**TOWN OF WINTER PARK  
PLANNING COMMISSION**  
Tuesday, September 10, 2024 8:00 AM

- a. Minutes – August 27, 2024
- b. Minor Site Plan - Riverwalk at Winter Park - Lot 18 – 135 Apres Way (PLN24-048)
- c. Minor Site Plan - Riverwalk at Winter Park - Riverfront Pavilion (PLN24-046) and Central Amenity Area and Entry Gates (PLN24-047)

**TO** Planning Commission  
**FROM** James Shockey, Community Development Director  
**DATE** September 10, 2024  
**RE** Riverwalk at Winter Park, Lot 18 (PLN24-048)

Sheet Title:  
**LOWER LEVEL PLAN**

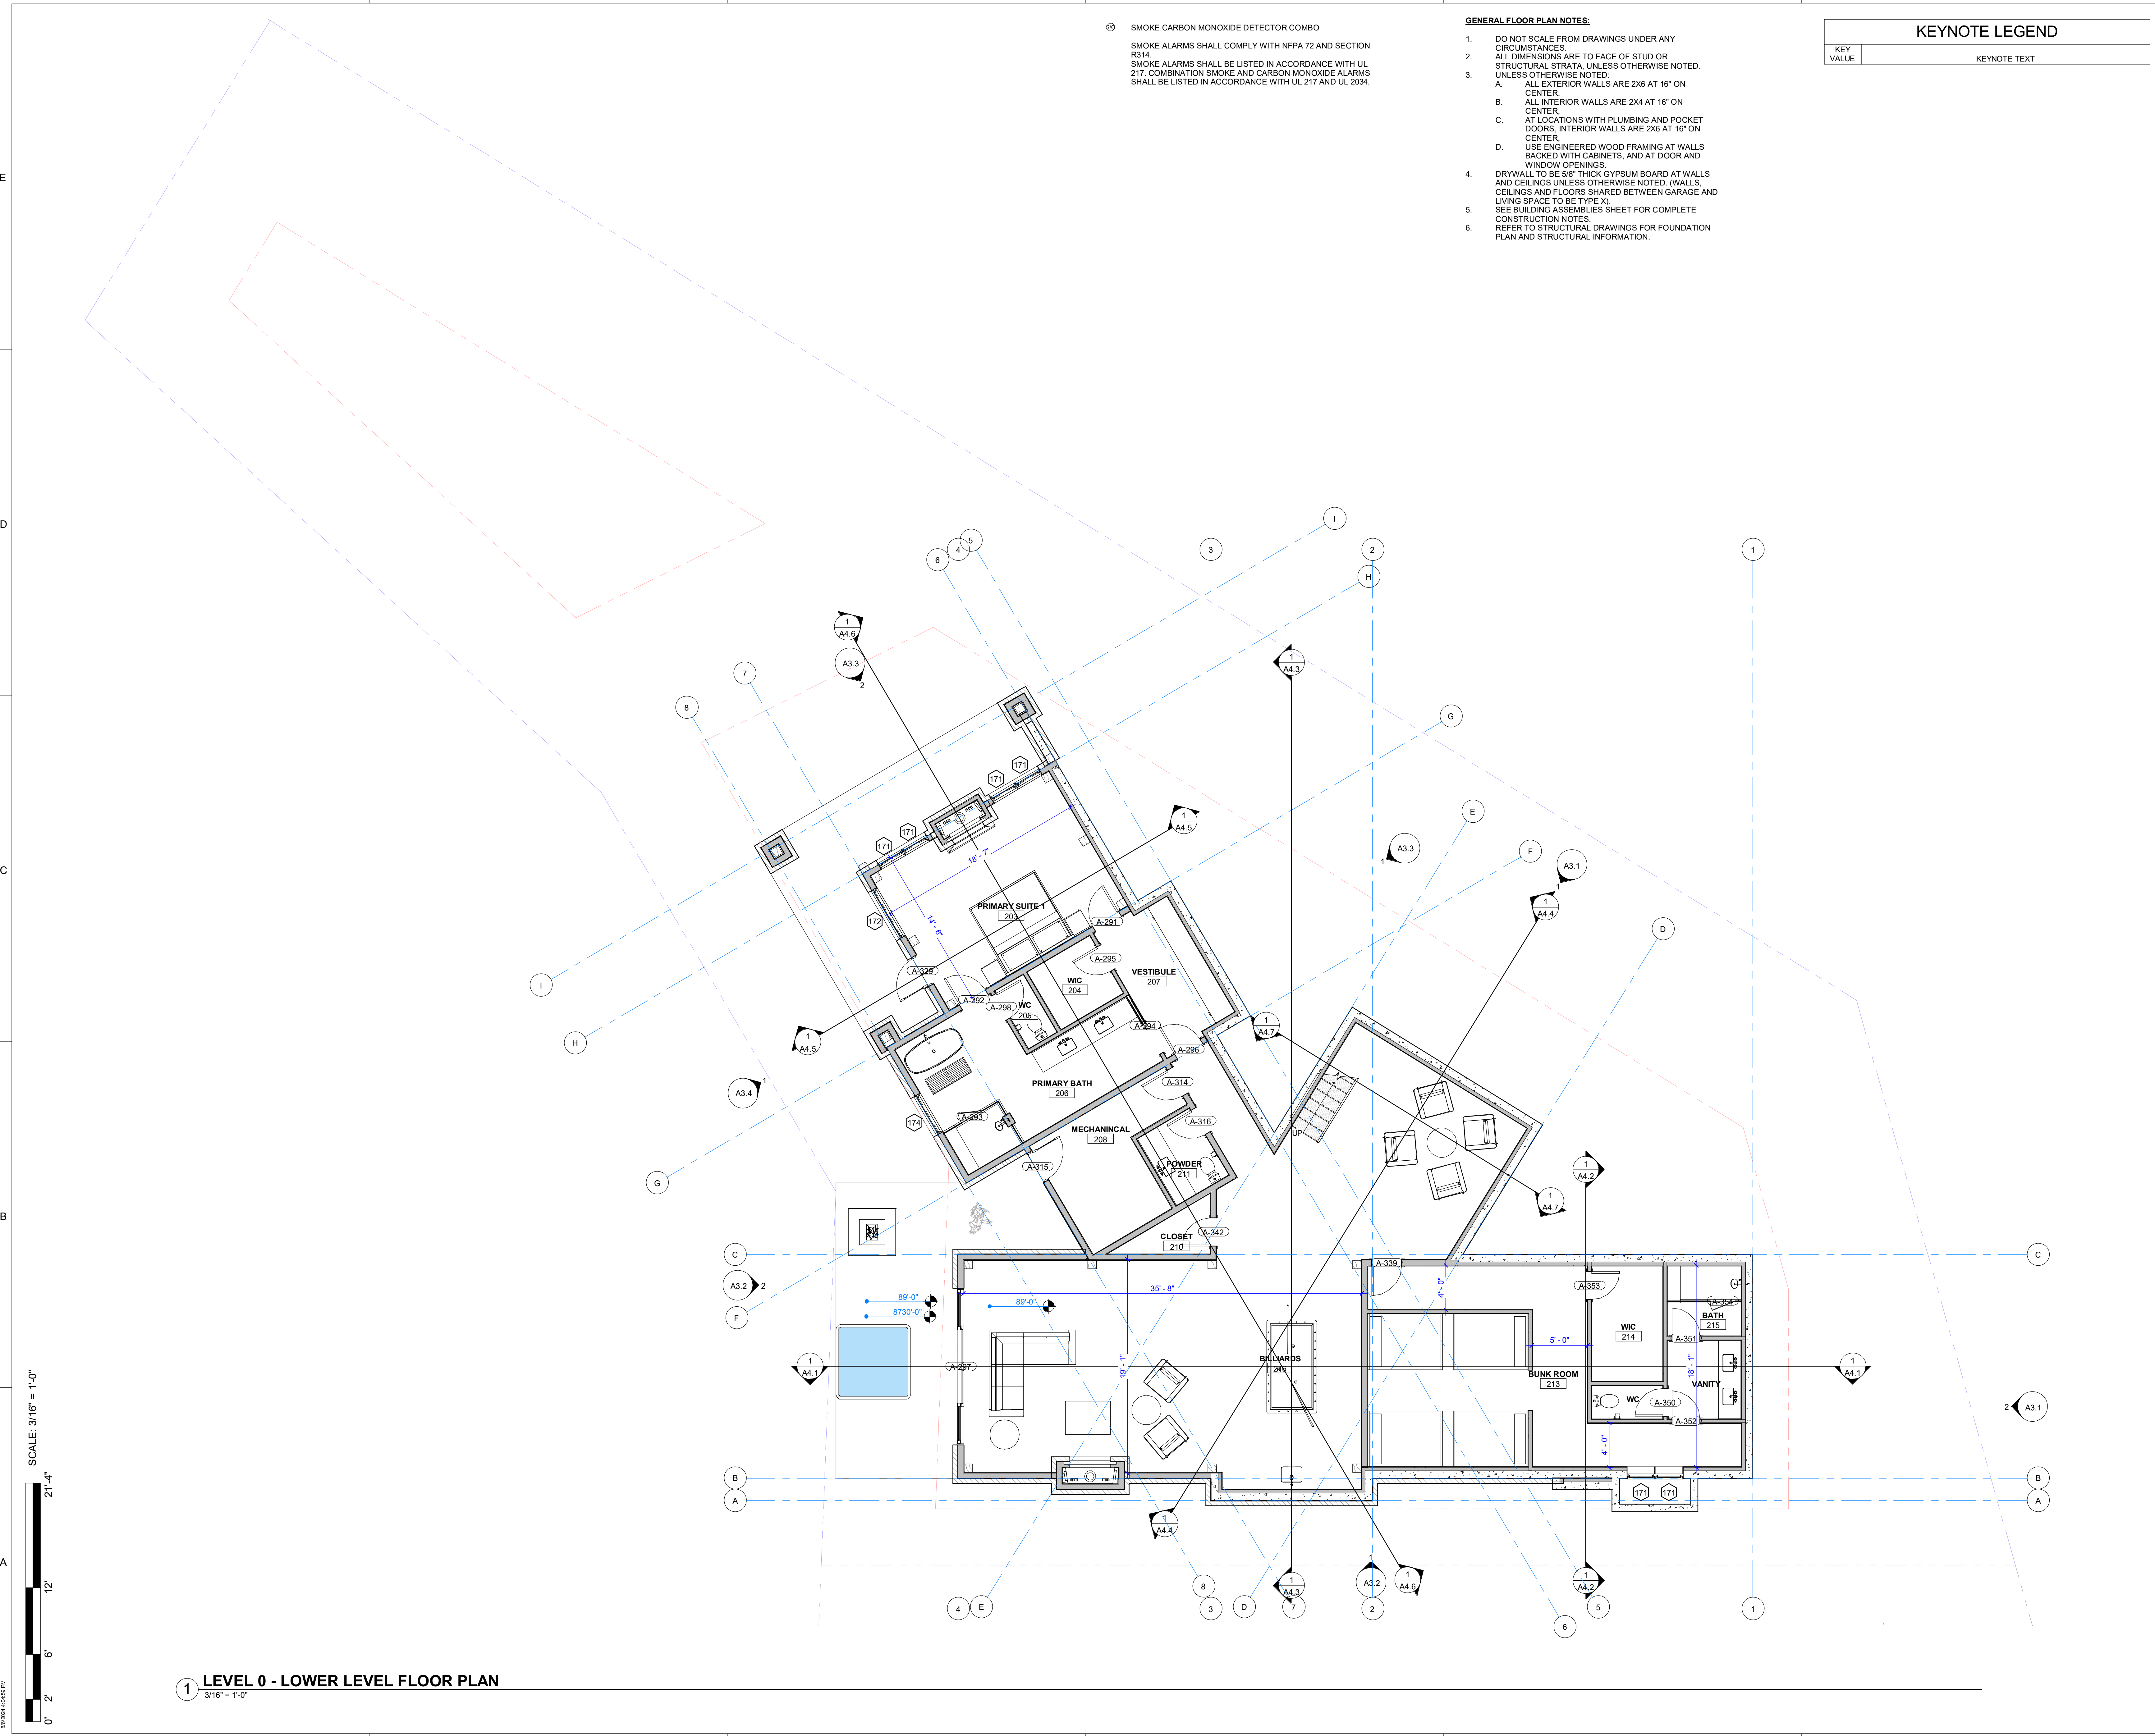
Unsatisfactory. There are three floors total. Floor plans do not indicate the square footage for individual rooms or entire floor. A roof plan was not included in the submittal. Notes indicate that the elevation documents contain additional information on the roof, but the elevation plans primarily outline materials.

- Applicant shall provide a roof plan as another sheet with the floor plans.
- Applicant shall provide square footage for each room in the floor plan or provide total square footage of each floor in the floor plan.

### LANDSCAPE LEGEND

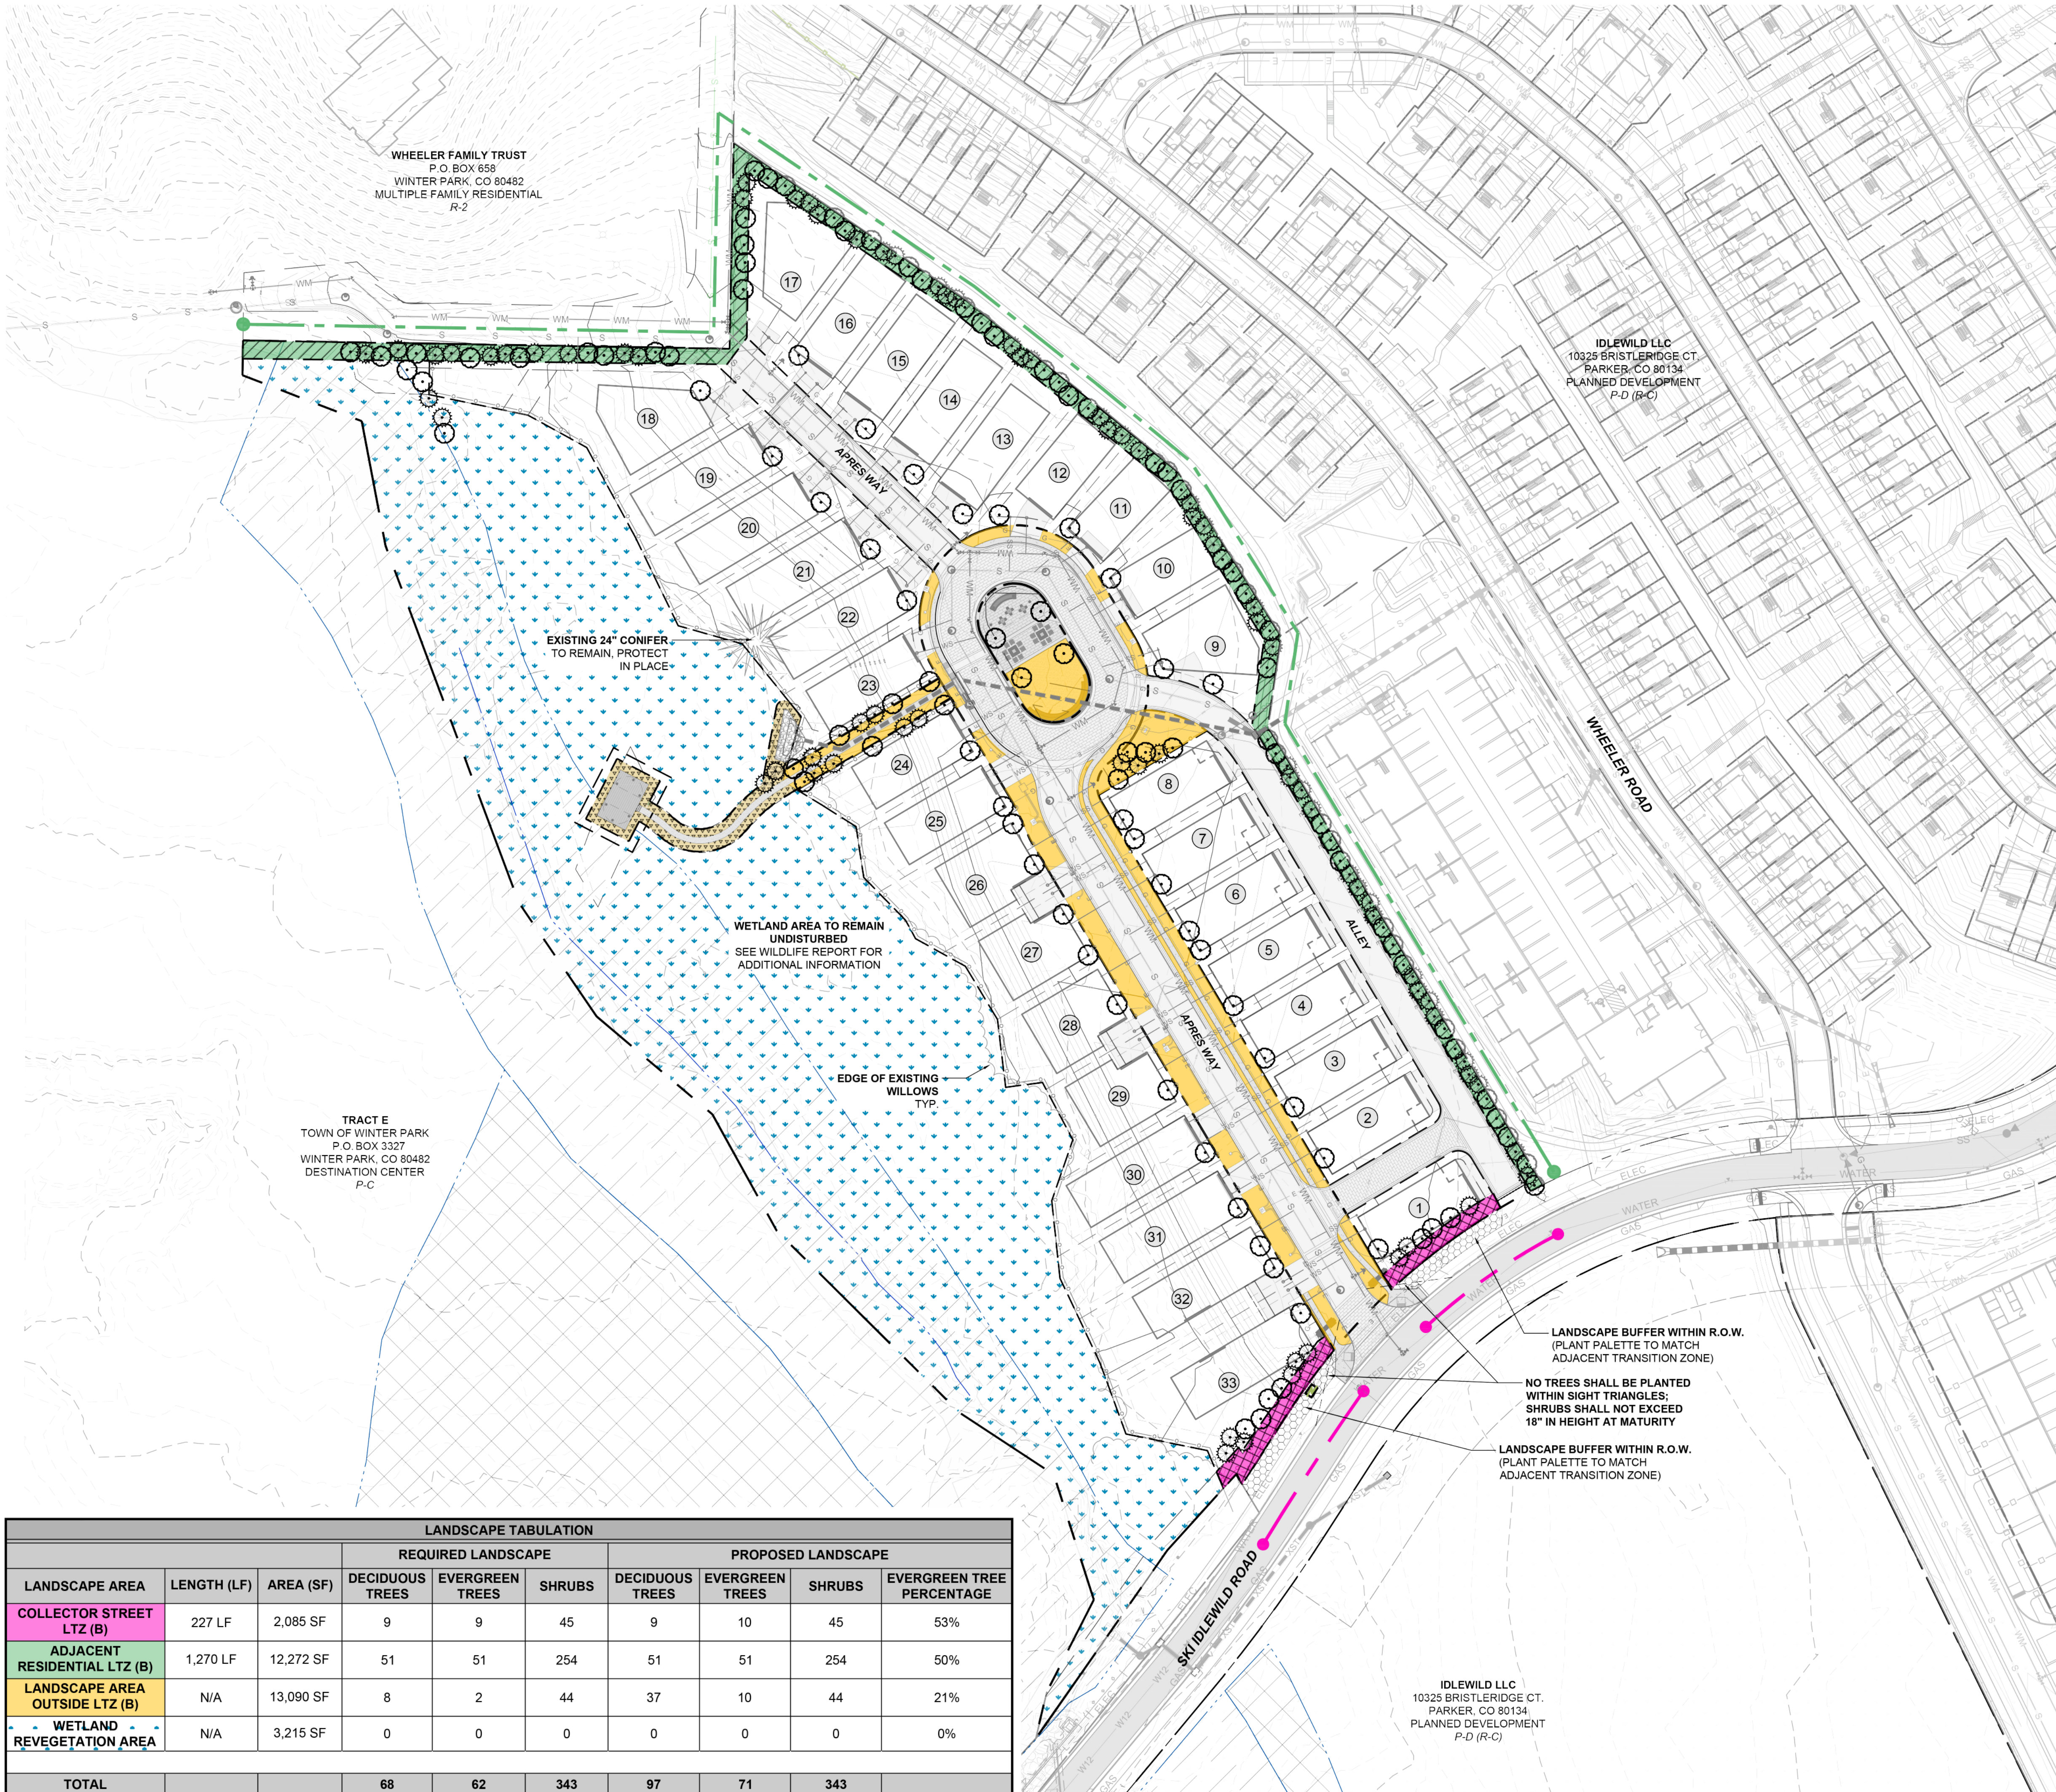
Unsatisfactory. The FDP, states that lots in Riverwalk are required to follow the Town of Winter Park Landscape Design Regulations and Guidelines. Tree Removal and Protection plans are not required for single family minor site plans. According to the FDP, a Residential LTZ (B) is located along the northern property line. The landscape plan is not at a proper scale to effectively evaluate the buffer. The buffer yard details are included in the site plan application but indicate the total, instead of those specific to Lot 18. The overall buffer yard provided was approved with the FDP. The applicant shall update the Landscape Plan in compliance with the UDC and FDP.

- The landscape plan does not provide a landscaping plan specific to Lot 18. It only depicts the overall landscape plan approved with the FDP. Provide a Landscape Plan, scale of 1' = 20', for Lot 18 that includes the following:
  - a. Proposed species name.
  - b. Property lines labeled with required bufferyard types.
  - c. Structures, existing and proposed.
  - d. Landscaping, existing and proposed.
  - e. Hardscaping, existing and proposed.
  - f. Top-of-wall and bottom-of-wall elevations of all retaining walls and site walls.
